Project Number: SP2018-014

Job Address: 6519 HORIZON RD

RE: SITE PLAN (SP2018-014), See Conditions -- Woodhill Dental

SP2018-014 Site Plan for Woodhill Dental: Please address the following comments (M= Mandatory Comments; I = Informational Comments)

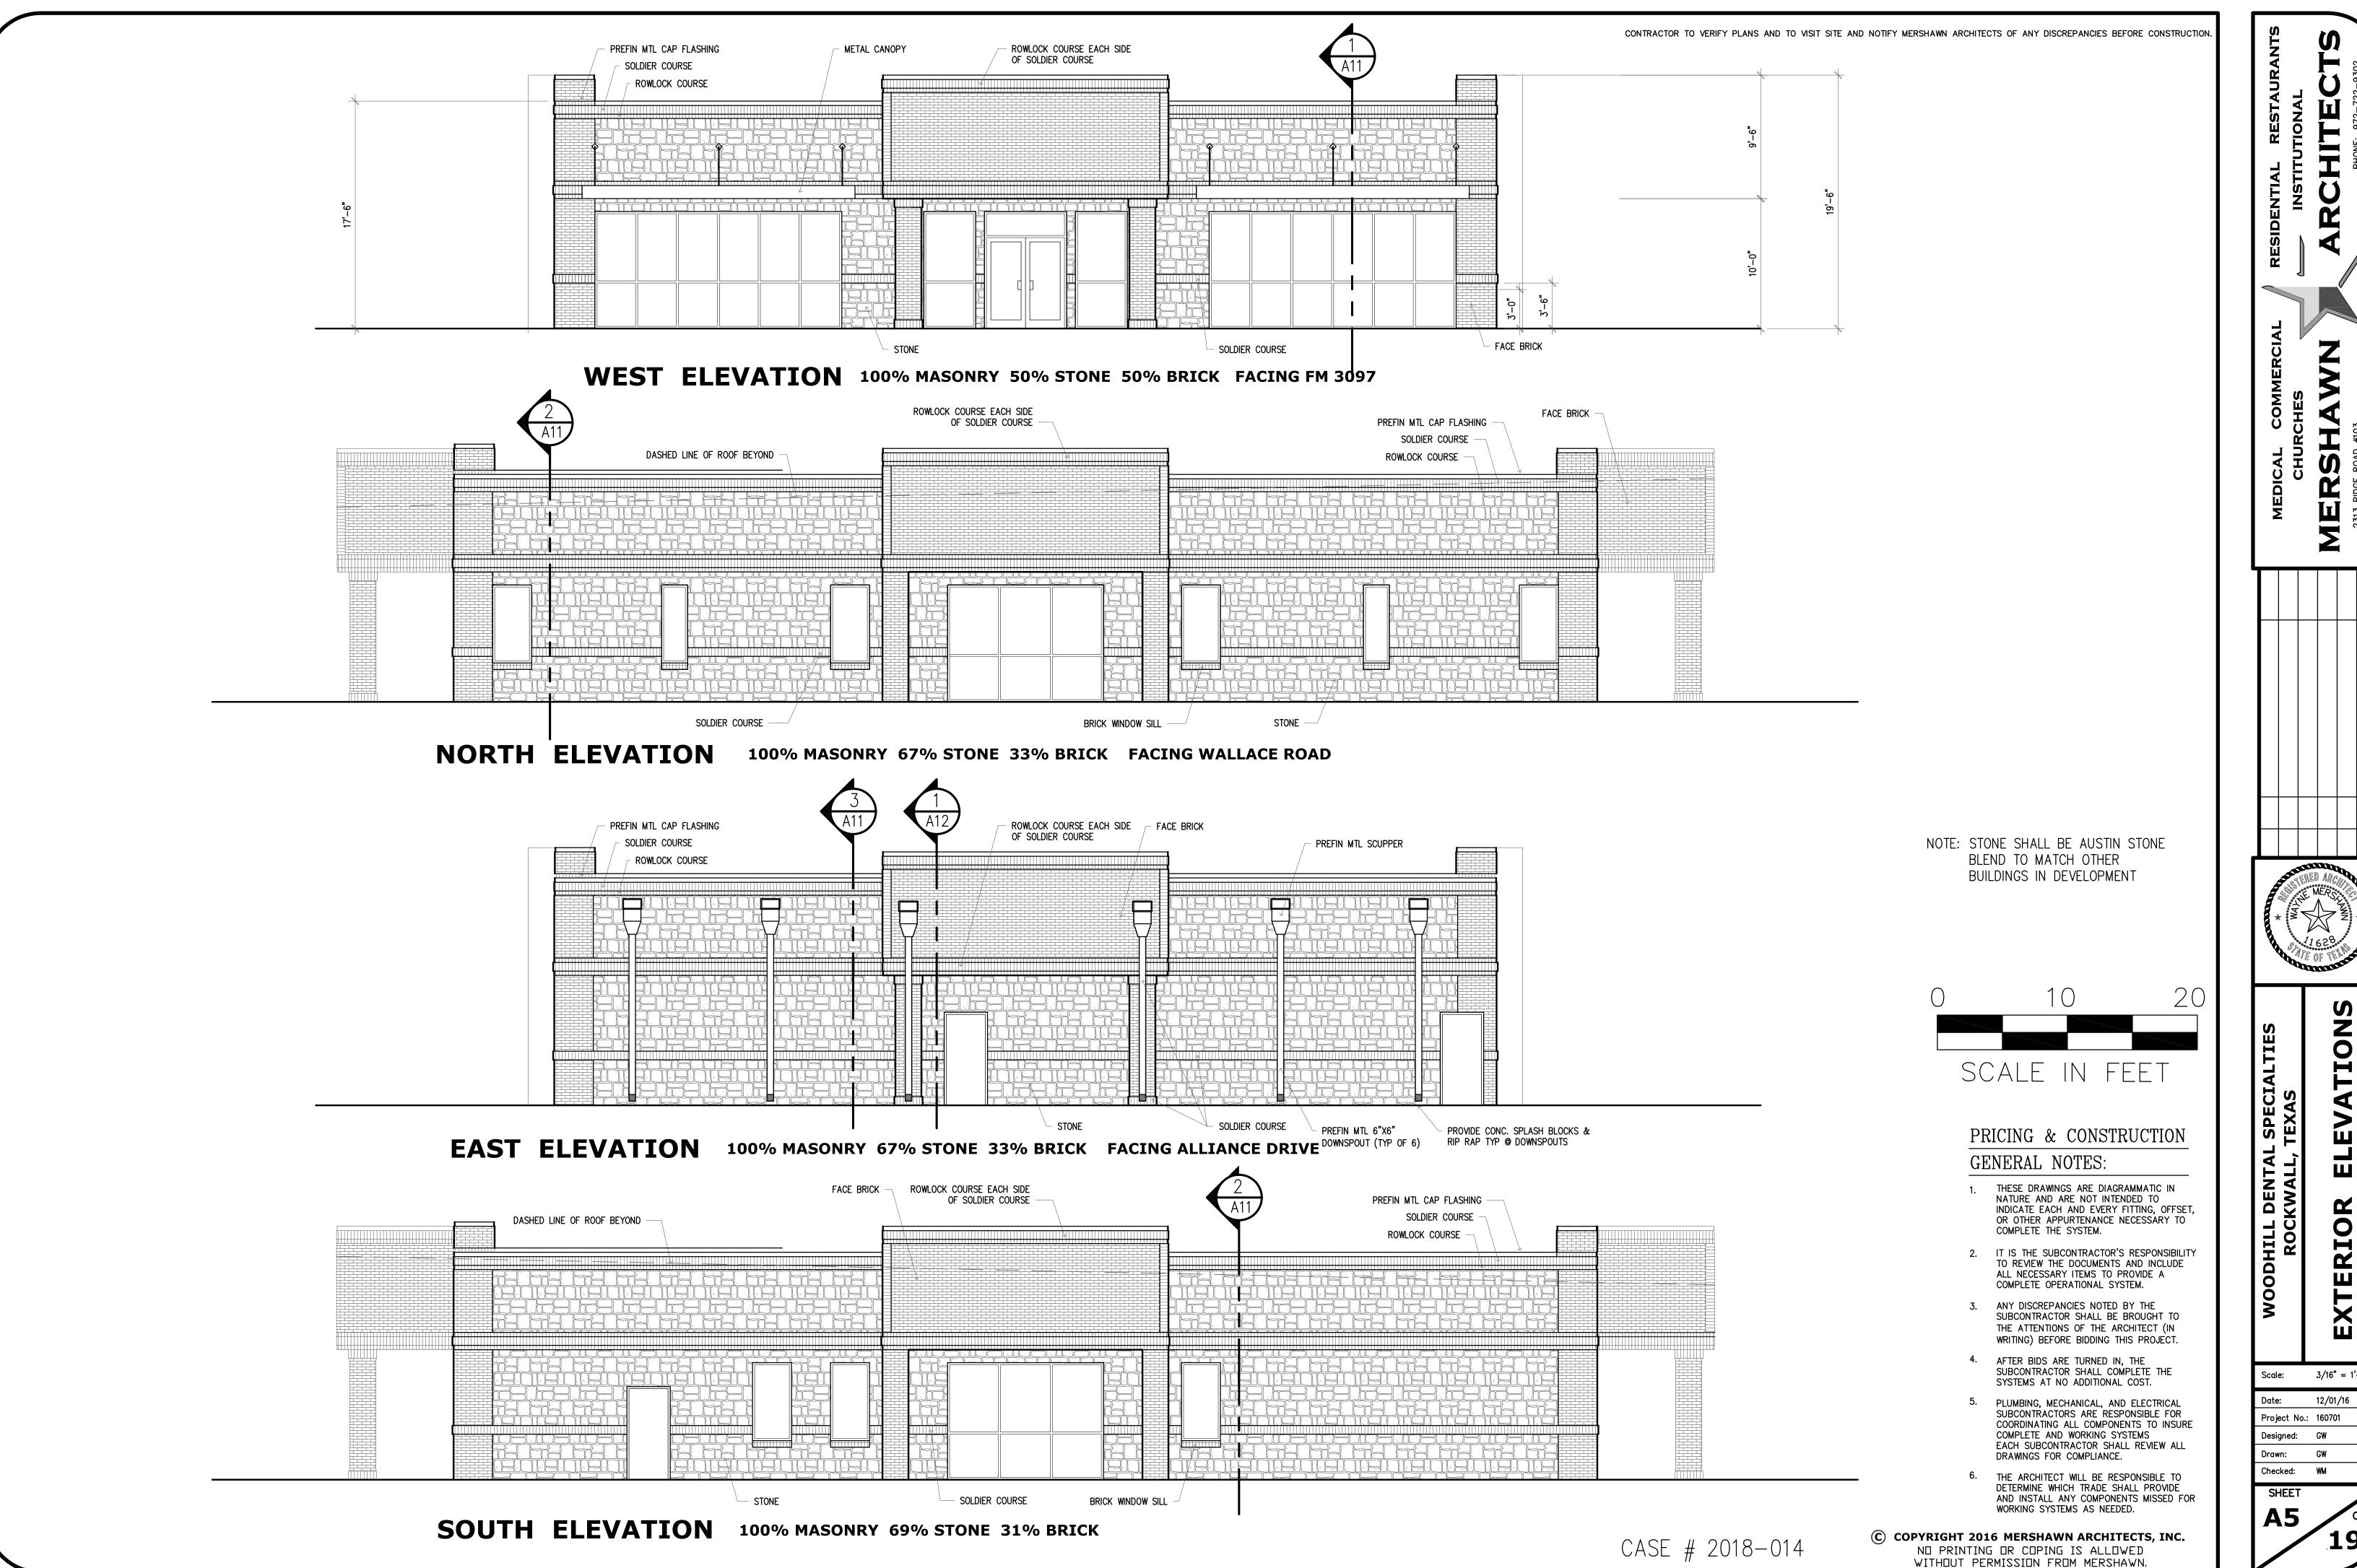
- M.25 Landscape Plan. Please show and label easements.
- M.26 Landscape Plan. Please show centerline for all adjacent roadways
- M.27 Photometric Plan. Please darken property line on photometric plan.

- M.28 Photometric Plan. Please provide cut sheets.
- M.29 Photometric Plan. Please note that any light over 15-watts shall be directed downward with a partial or full cutoff

- M.30 Photometric Plan. Please provide site data table as shown on Landscape Plan.
- M.31 Photometric Plan. Please provide elevation of any light poles.

- M.32 Photometric Plan. Please show centerline of all adjacent roadways.
- M.33 Building Elevations. Please see PD-57 standards. This building does not appear to match the theme of the existing buildings.

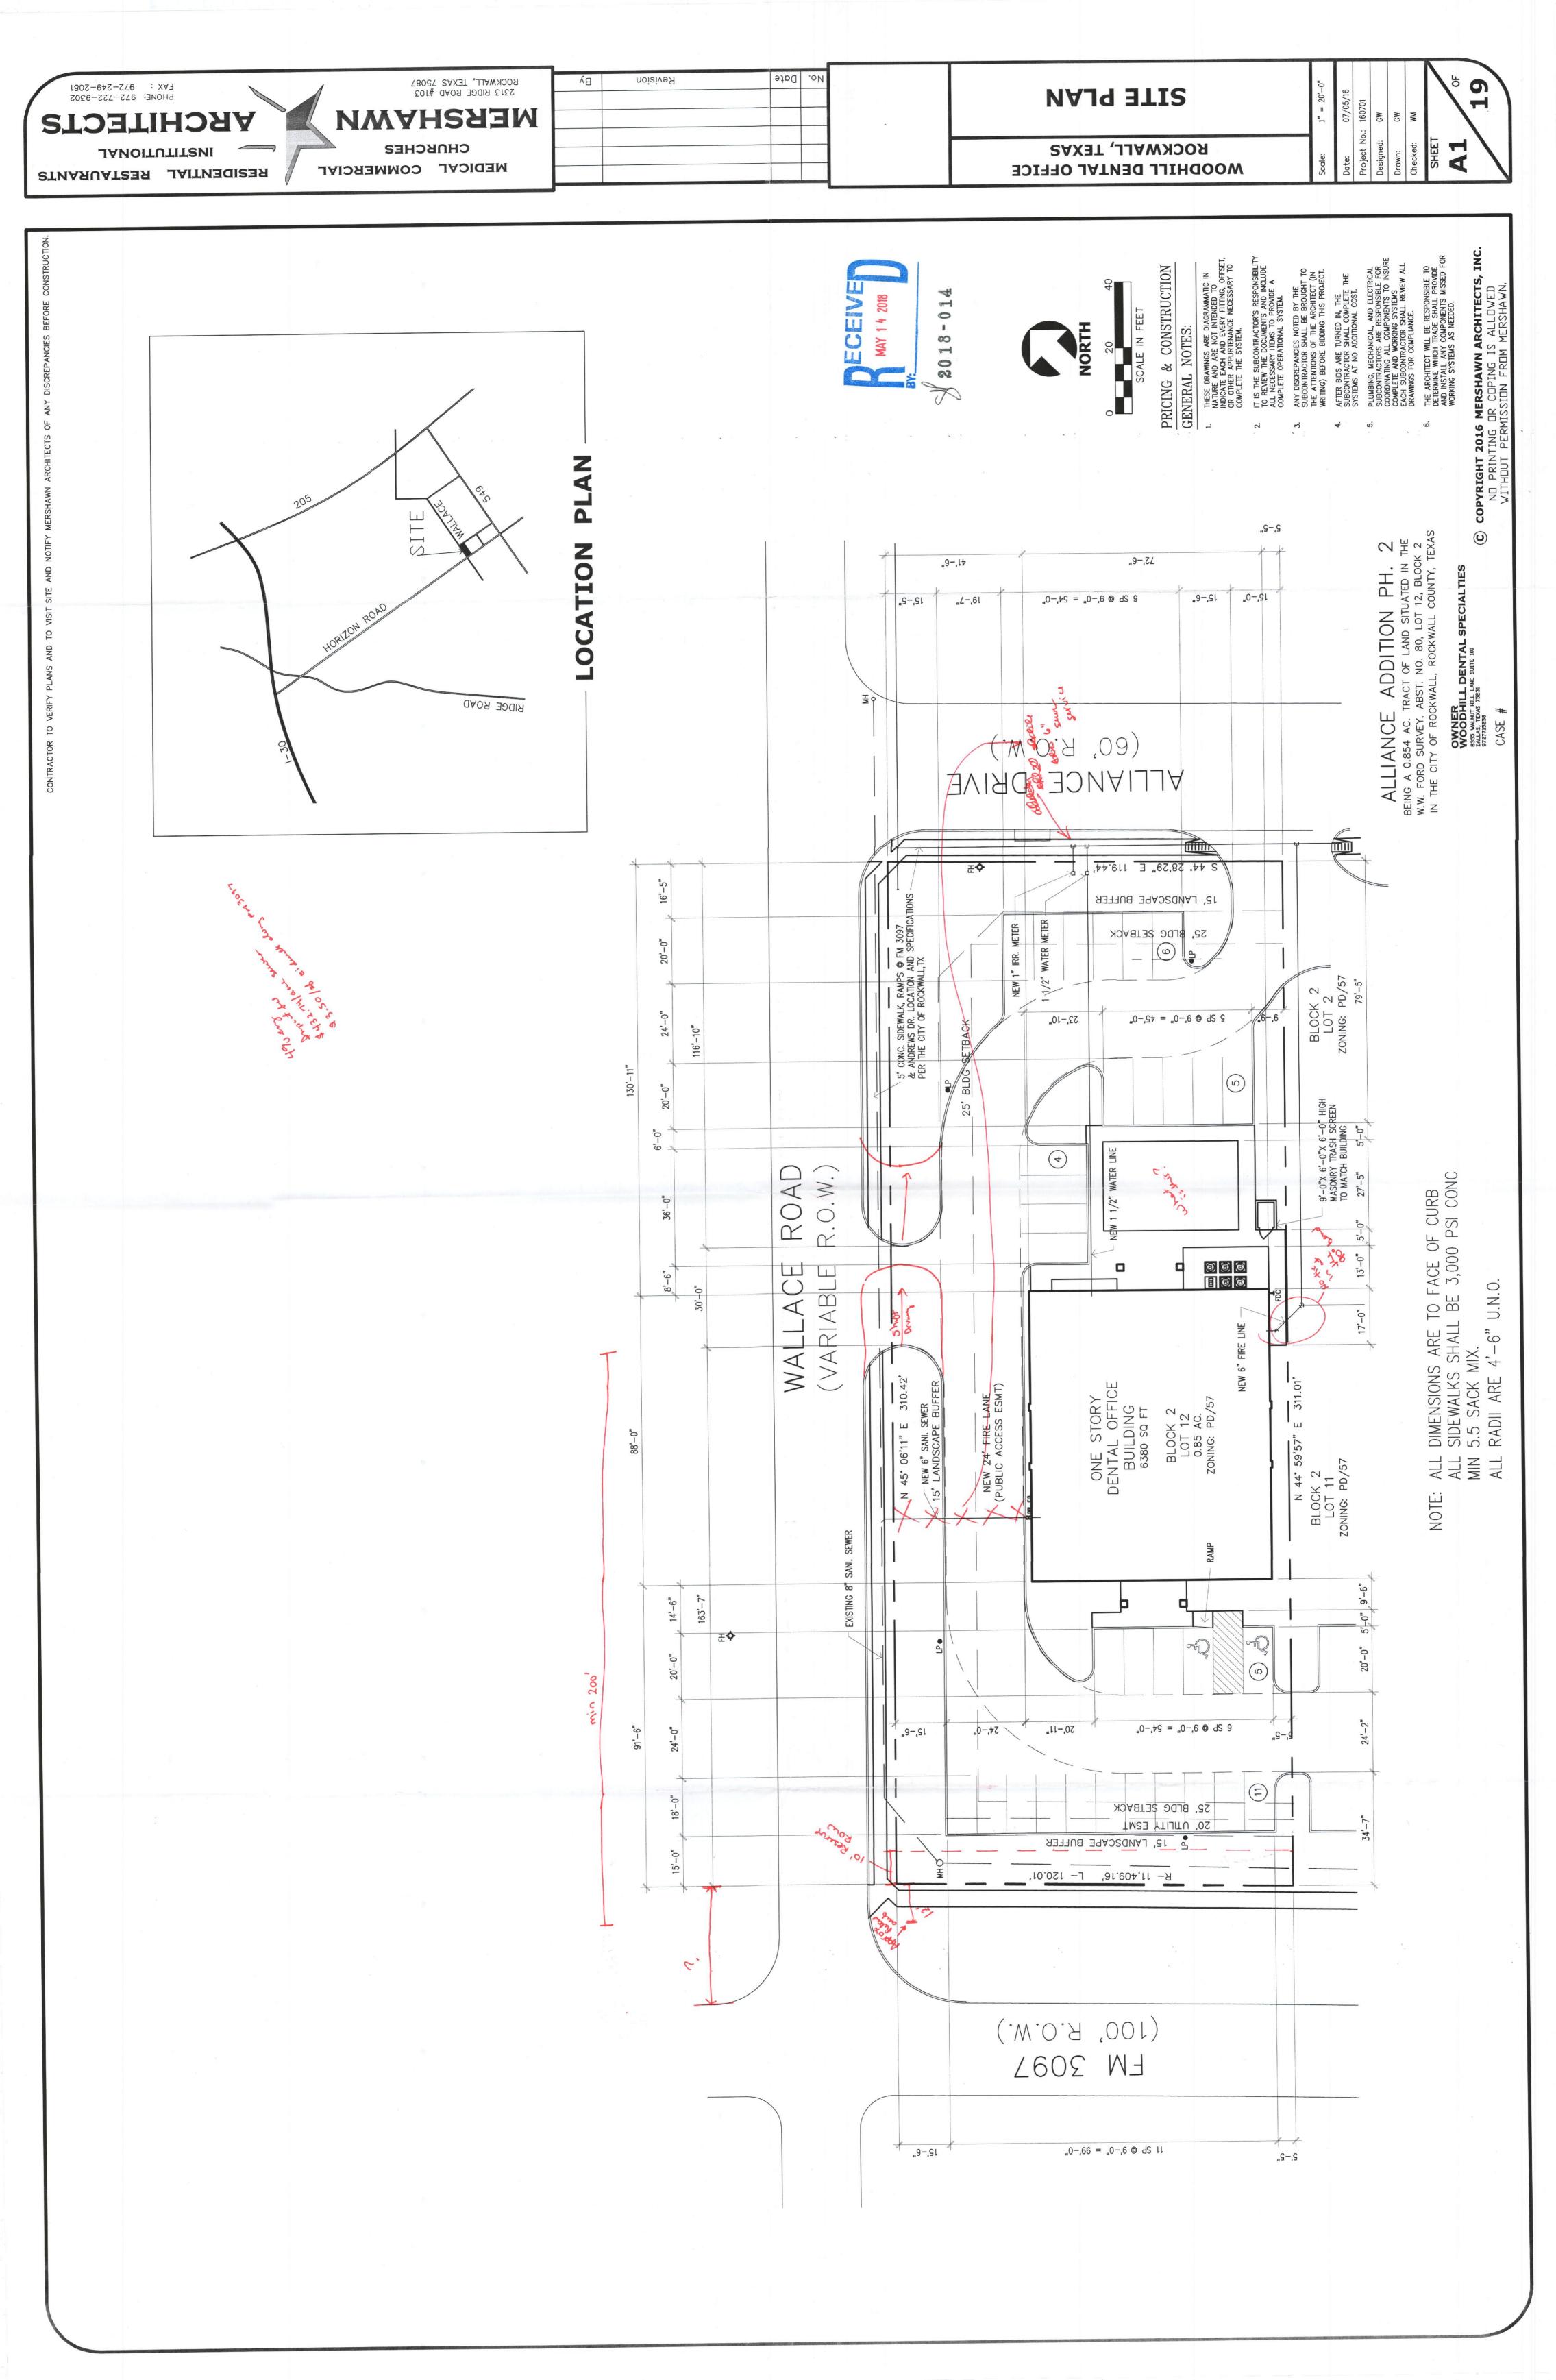
- M.34 Building Elevations. Please provide material percentages per façade. Subtract windows and doors.
- M.35 Building Elevations. Please indicate the elevation that faces the street.

- M.36 Building Elevations. Please provide color elevations.
- M.37 Building Elevations. Please note that as proposed, this will need a variance for vertical and horizontal articulation. Please see the vertical and horizontal articulation requirements for Commercial (C) District.

- M.38 Building Elevations. If the building elevations are scalable, pleaseprovide scale.
